**APPLICABILITY:** 2015MY Outback Models

**NUMBER:** 12-202-16

**SUBJECT:** Rear Gate and Rear Gate Buffer Information

**Water Drain Plug**

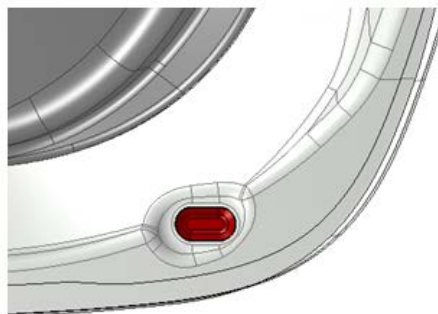
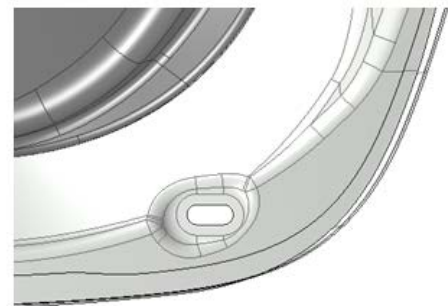
This bulletin describes a design change to the rear gate panel eliminating the plugs previously installed in the lower outer corner water drain holes. As a result of this change, there has been a change made to the rear gate buffers as described in the Service Procedure section below.

The new rear gate buffers were incorporated into production starting with VIN F\*207916.
